Service Bulletin

E263

PACCAR MX-13 EMY 2017 - 2018 Exhaust Valve Guide Seals

5/7/2020

Figure 2 Valve Guide Seal Locations

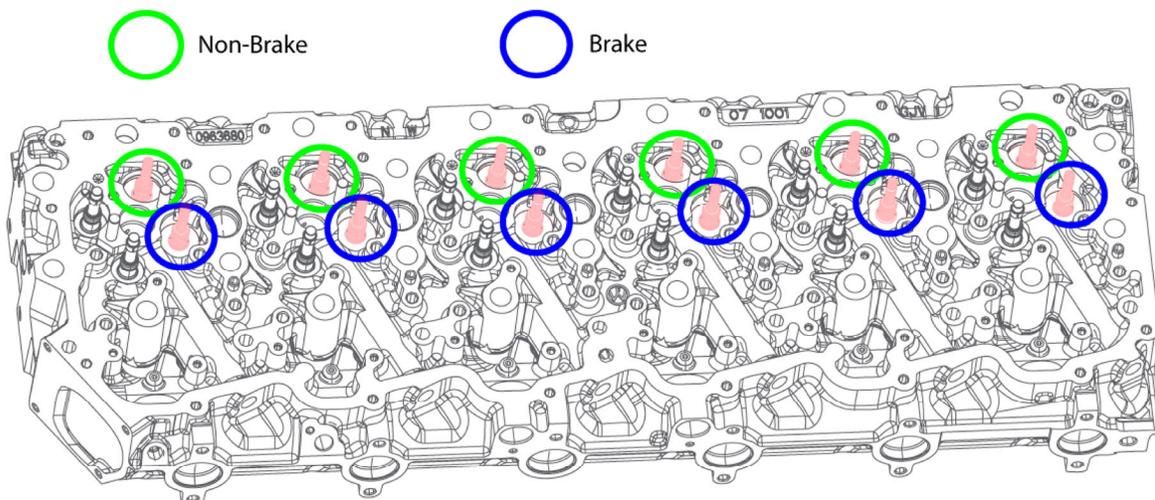
Replace only the exhaust seals. See the Valve Seal replacement job in RMI for instructions and refer to the following figure for the location and part number of the new seals and the Non-Brake spring washer.

i	NOTE
Check the valve spring keepers. Reuse them if there is no obvious wear.

Valve	Spring Washer	Seal
Non-Brake Exhaust Valve	2182962	1819065
Brake Exhaust Valve	N/A	2162785

Figure 1 Valve Guide Seal Locations

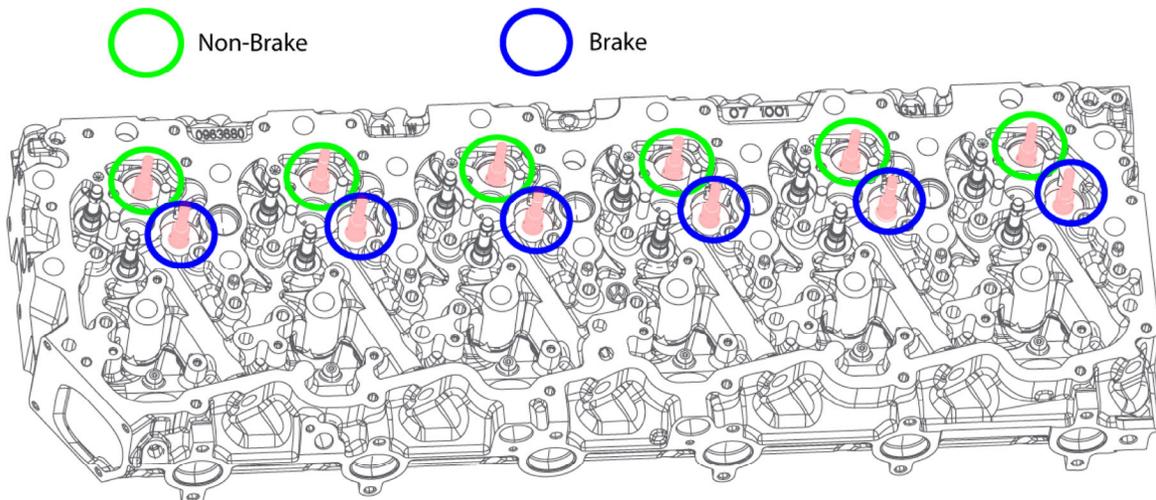
- Replace only the exhaust seals. See the Valve Seal replacement job in RMI for instructions and refer to the following figure for the location and part number of the new seals and the Non-Brake spring washer.

i	NOTE
Check the valve spring keepers. Reuse them if there is no obvious wear.

Valve	Spring Washer	Seal
Non-Brake Exhaust Valve	2182962	1819065
Brake Exhaust Valve	N/A	2162785
